Objection to Proposed Shannon LNG Terminal Planning Application by Gluaiseacht

Objection by: Gluaiseacht for Global Justice

Applicant: **Shannon LNG Limited**

An Bord Pleanála Case Reference: [PA08.311233](#)

Figure 1: New Fortress Energy Operations & Development but with Liquefaction assets excluded

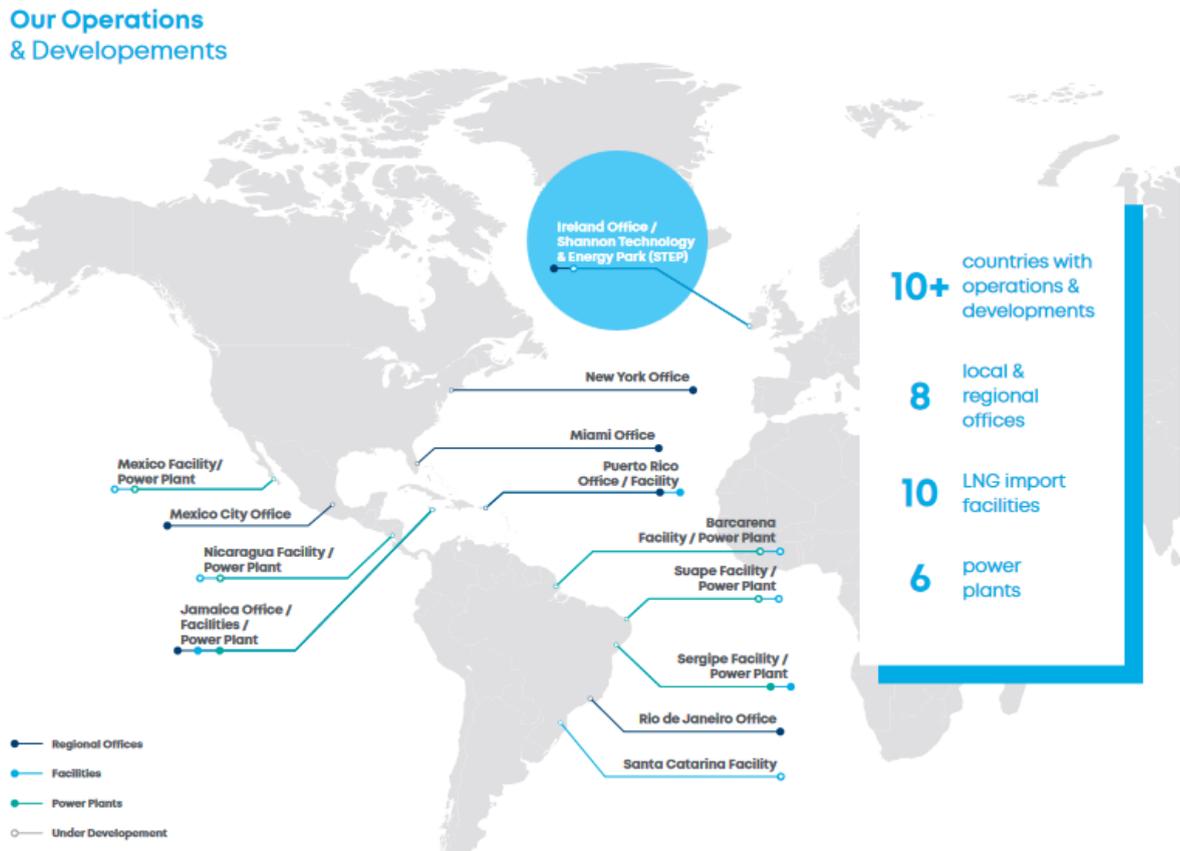
They have also misled ABP and the public in their current application as to the extent that their operations aren't based on fracked gas. Take for instance Figure 1 which is an image in their brochure taken from EIAR_Volume4, which purportedly lists New Fortress Energy's "Operations & Development"

In the application New Fortress Energy have deliberately excluded their operations in the US, from which they source their gas. This is because if New Fortress Energy included their Liquefaction Assets in the image it would make clear how their whole operation is dependent on fracked US gas.

Why have the applicants excluded these operations from the "Our Operations & Developments" Map and the application. The simple answer is that it is fracked gas coming from the Marcellus area of Pennsylvania.

Figure 2: New Fortress Energy promotional video showing the increase in US fracked gas production

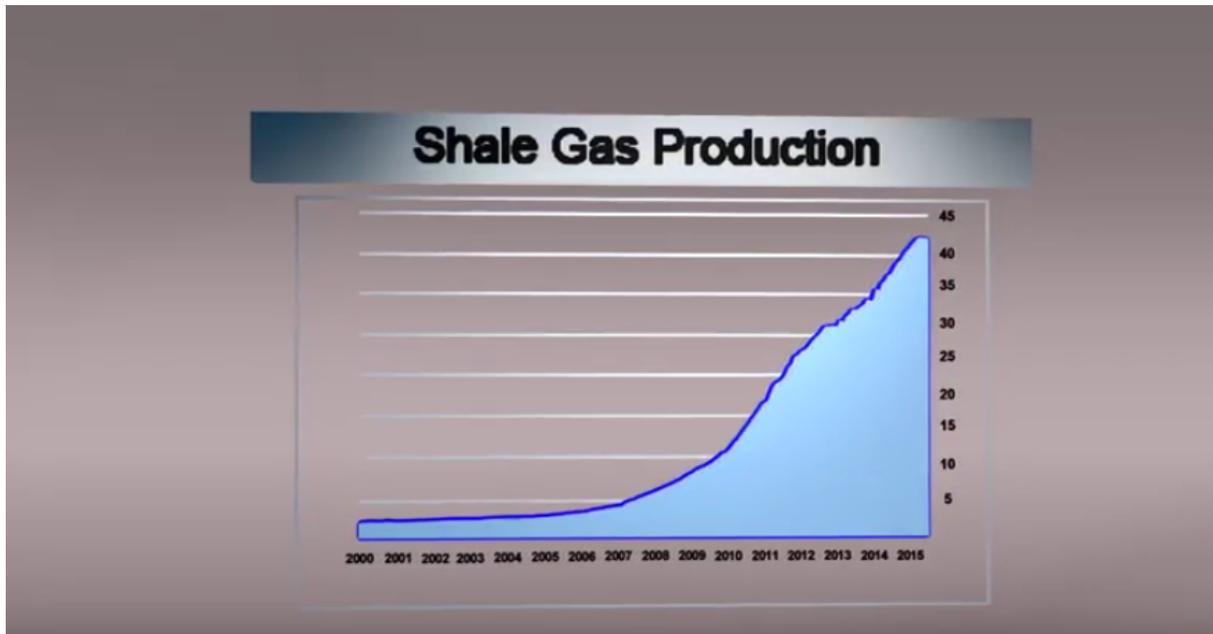
It can be seen from this New Fortress Energy promotional video how they are attempting to get South America hooked on US fracked gas. They are attempting to do the same to Ireland with the Shannon LNG project: <https://www.youtube.com/watch?v=rF1KMRVqa3k>
